UNITED STATES PATENT AND TRADEMARK OFFICE

APPLICATION NO.	FILING DATE	FIRST NAMED INVENTOR	ATTORNEY DOCKET NO.	CONFIRMATION NO.
09/777,693	02/07/2001	Jun Koyama	740756-002262	6699
22204	7590	07/25/2005	EXAMINER	
NIXON PEABODY, LLP 401 9TH STREET, NW SUITE 900 WASHINGTON, DC 20004-2128			SHAPIRO, LEONID	
			ART UNIT	PAPER NUMBER
			2677

Office Action Summary

FIG. 28

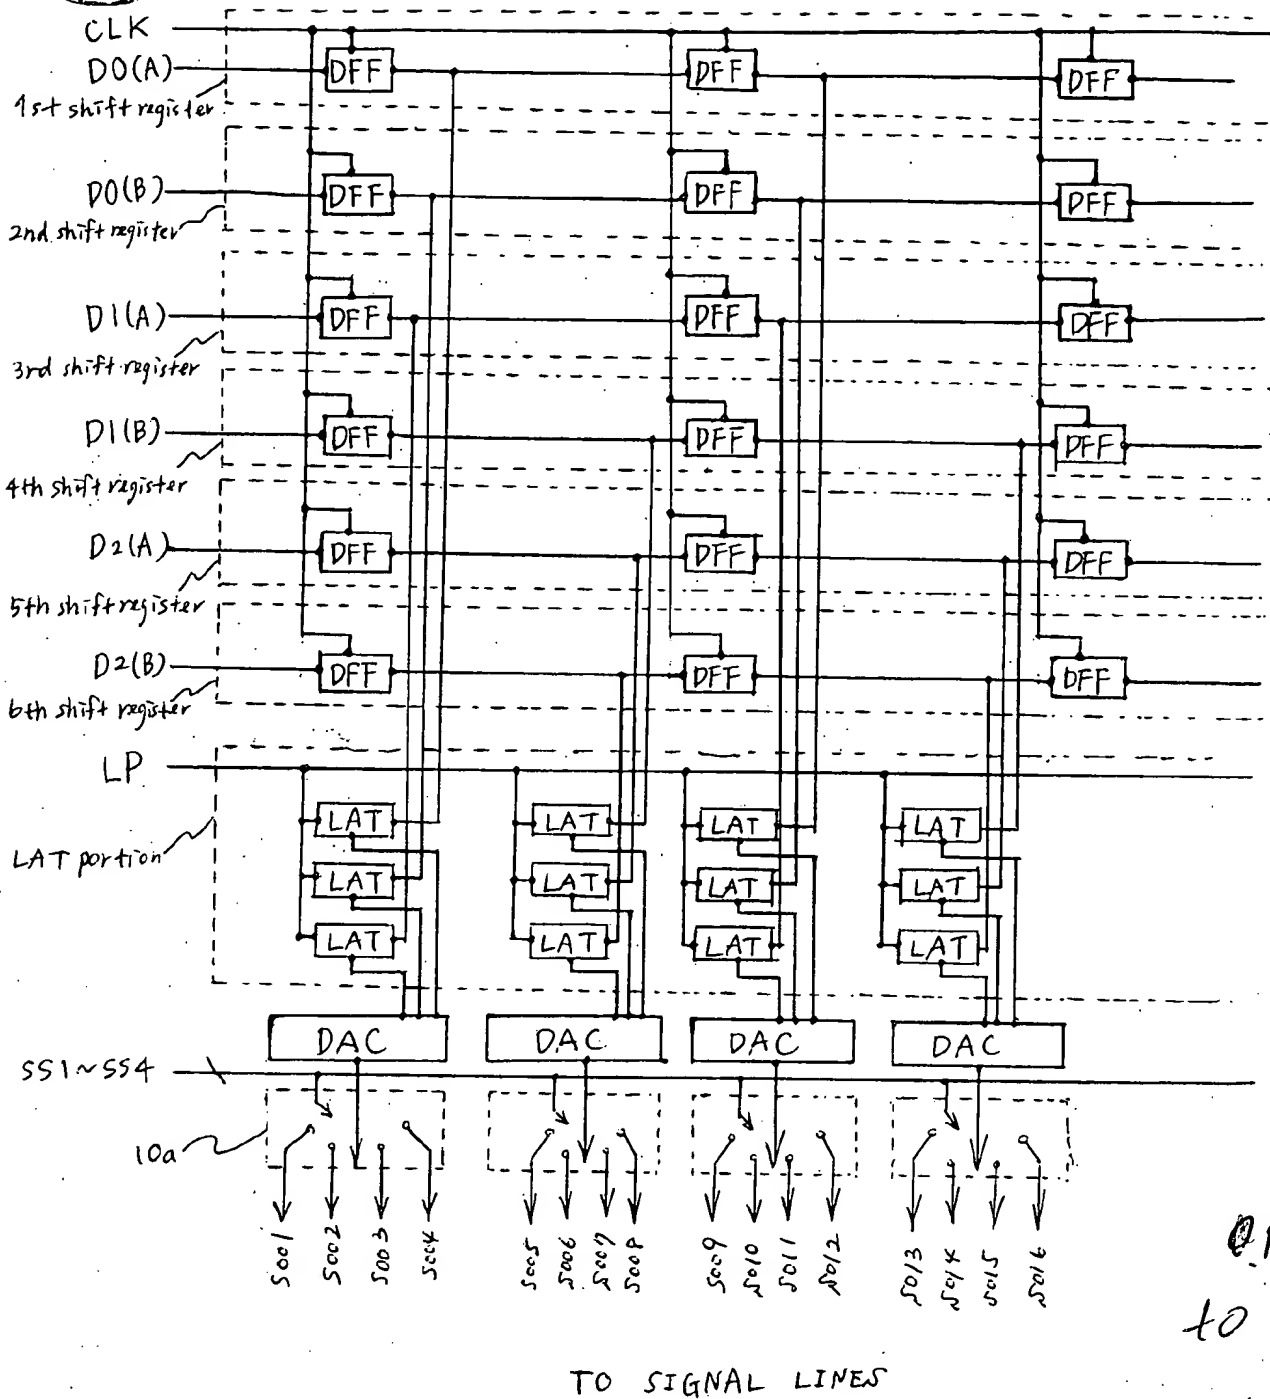
OK -
to enter.
